SUBJECT: Calvert Cliffs Nuclear Power Plant
Unit Nos. 1 & 2; Docket Nos. 50-317 & 50-318
Response to NRC's Request for Additional Information Regarding
Baltimore Gas and Electric Company's Response to the 1991 Pressurized
Thermal Shock Rule, dated March 31, 1992.

Non-Proprietary Response to NRC's March 31, 1992 Request for Additional Information
Regarding Baltimore Gas and Electric Company's Response to the 1991 Proposed
Thermal Shock Rule, dated December 13, 1991

RESPONSE TO USNRC QUESTION ON
DIFFERENCES IN REPORTED NICKEL CONTENT

FIGURE 1: NRC RAI CATEGORY 1 & 2 SURVEILLANCE DATA
MEASURED RT_{ndt} SHIFT VS. PREDICTED RT_{ndt} SHIFT

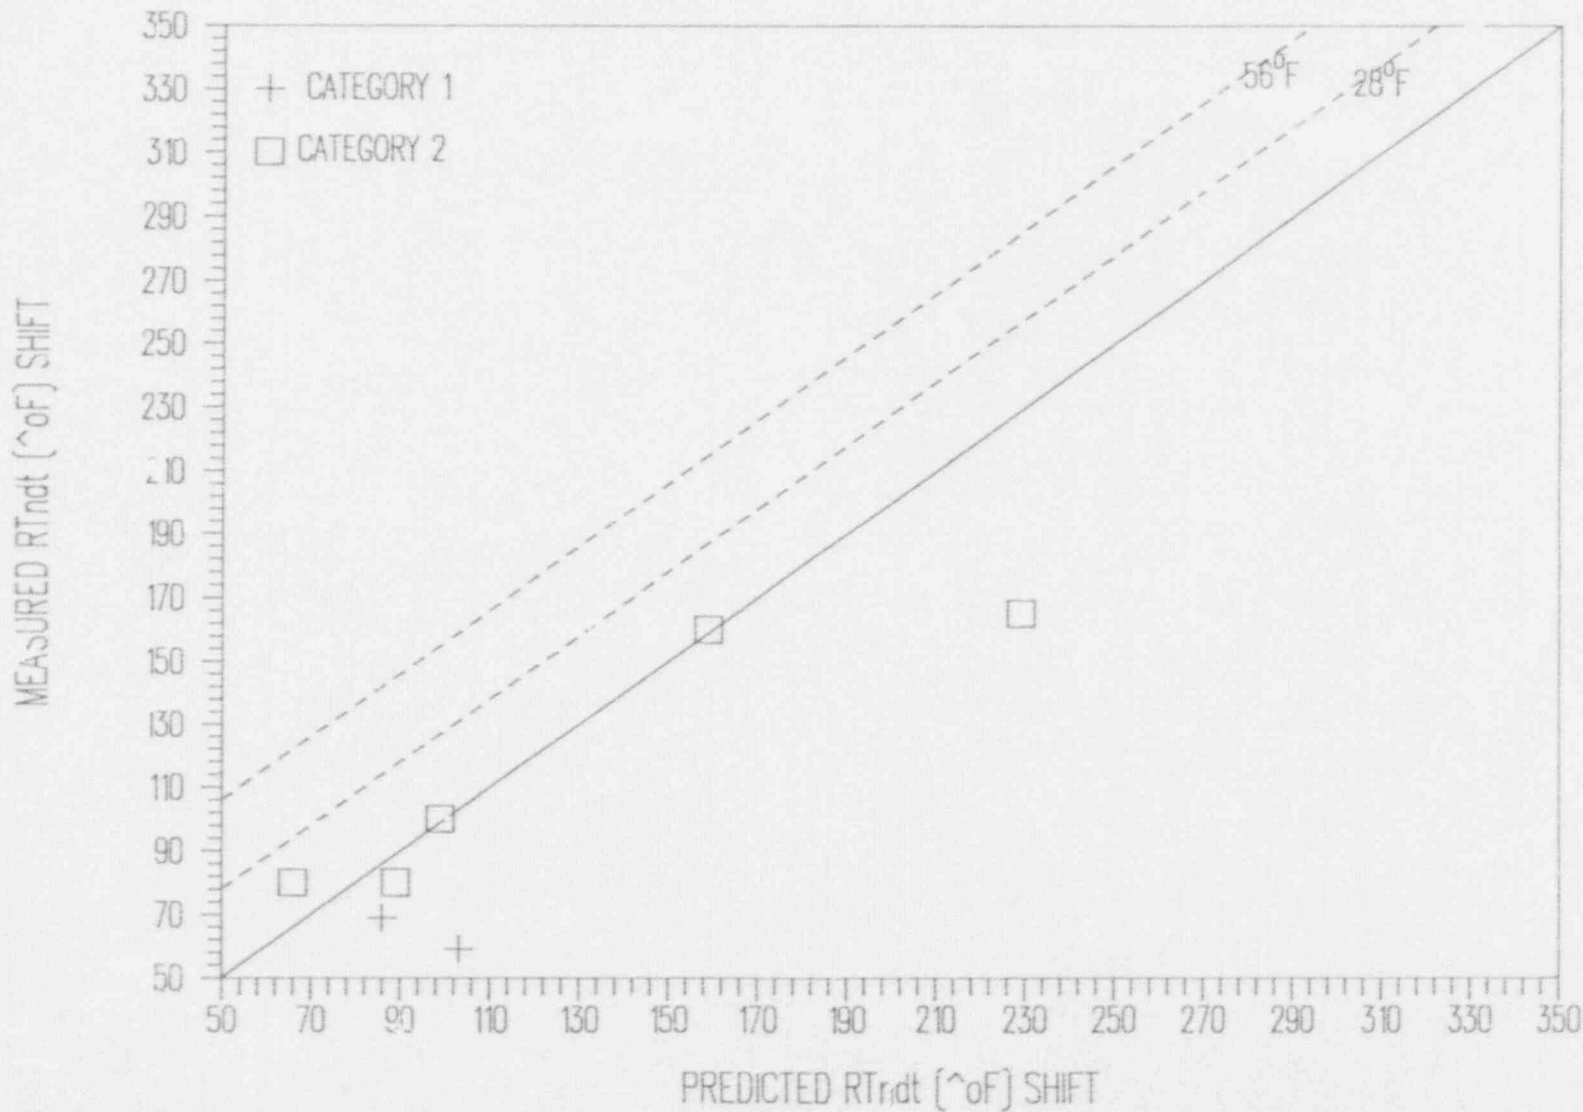
Question No. 2

Do the test results from the Calvert Cliffs reactor vessel surveillance program indicate that the values of Pressurized Thermal Shock (PTS) calculated using the methodology specified in the PTS rule are applicable to the Calvert Cliffs reactor vessels?

Test results from Category 1 and 2 surveillance programs indicate the values of ΔRT_{PTS} calculated using the methodology specified in the PTS rule bound the surveillance measurements.

Figure 1 provides a comparison of Category 1 and 2 Surveillance results to the PTS rule predictions. Figure 2 provides a comparison of Category 3 Surveillance results to the PTS rule predictions.

The figures compare measured and predicted values of ΔRT_{NDT} instead of RT_{PTS} . Calculation of measured values of RT_{PTS} requires application of a margin term. Methodology for choosing a margin term for measured data that do not meet the credibility criteria in Regulatory Guide 1.99, Revision 2 has not been developed. Therefore, we have not determined values of RT_{PTS} based on measurements, for application of other vessel's surveillance data to Calvert Cliffs.

Based on the review of these test results, BG&E believes the values of ΔRT_{PTS} for the Calvert Cliffs Reactor Vessel Bellines reported in the Response to the 1991 PTS rule are applicable and probably conservative.

FIGURE 2: NRC RAI CATEGORY 3 SURVEILLANCE DATA
MEASURED RTndt SHIFT VS. PREDICTED RTndt SHIFT

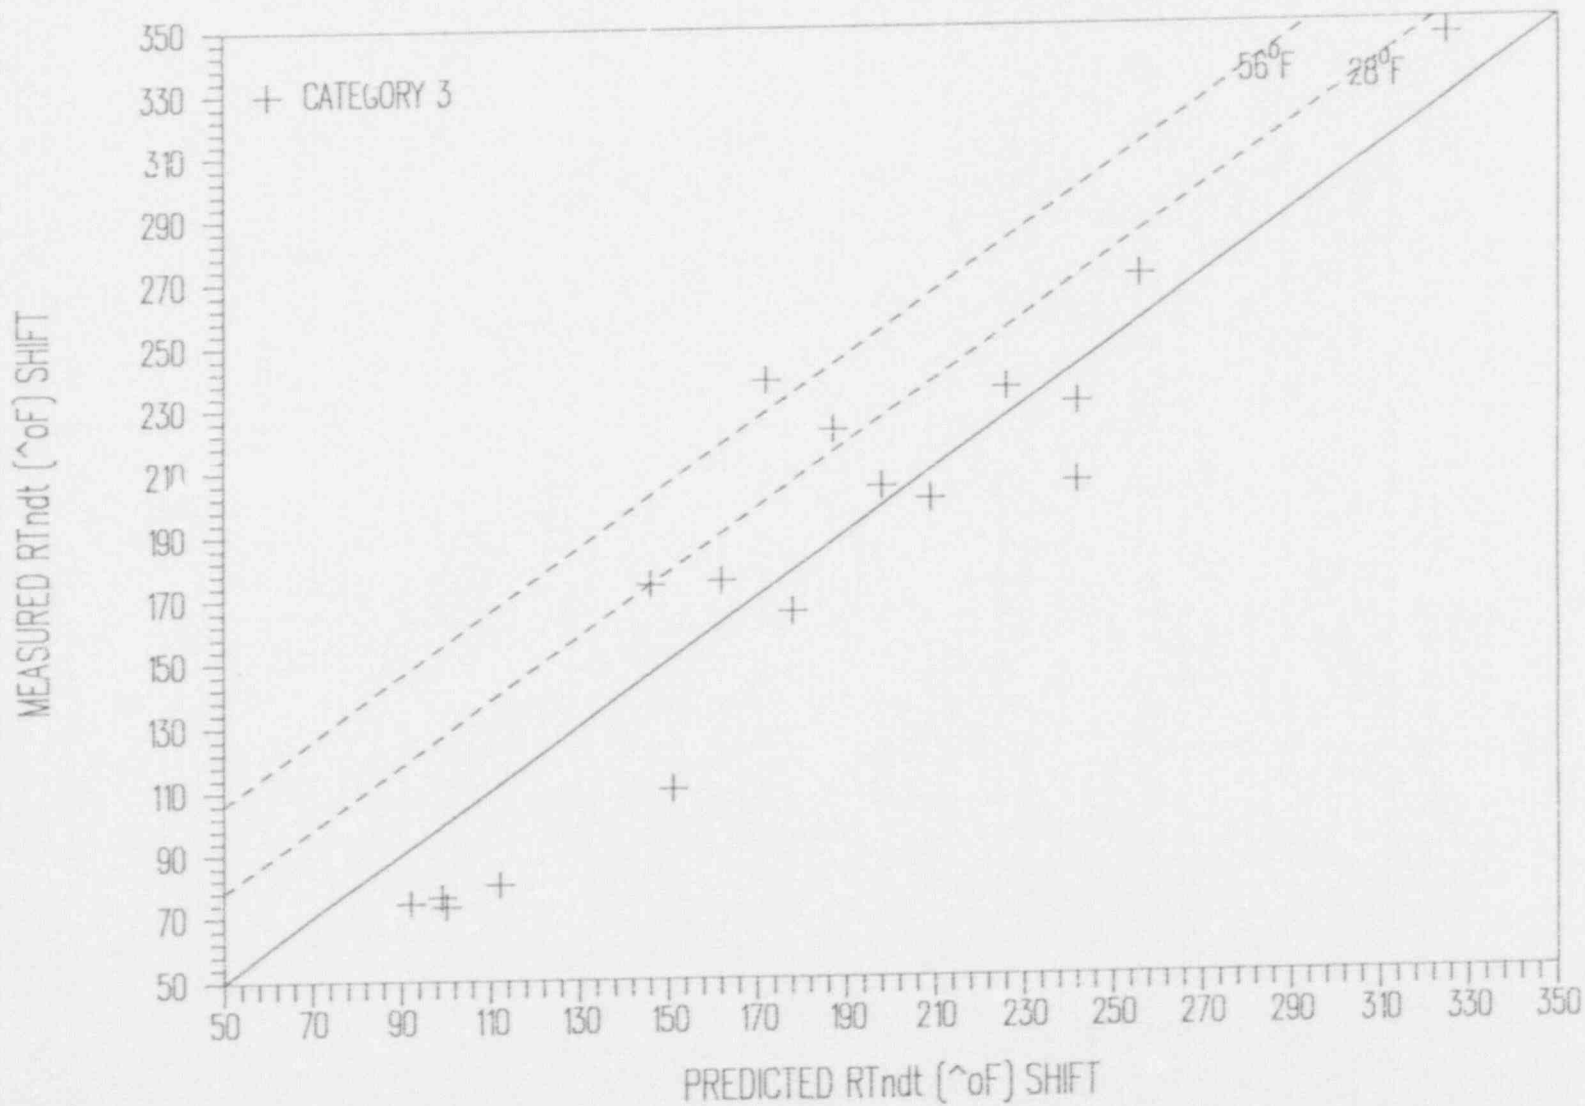
For weld wire heats not in the Calvert Cliffs reactor vessel surveillance program, do test results from other vessel surveillance programs (NRC data source provided with this RAI) indicate that the values of the PTS calculated using the methodology specified in the PTS rule are applicable to the Calvert Cliffs reactor vessels?

Test results from Category 3 surveillance programs indicate the values of ΔRT_{PTS} calculated using the methodology specified in the PTS rule bound the surveillance measurements with the exception of Fort Calhoun.
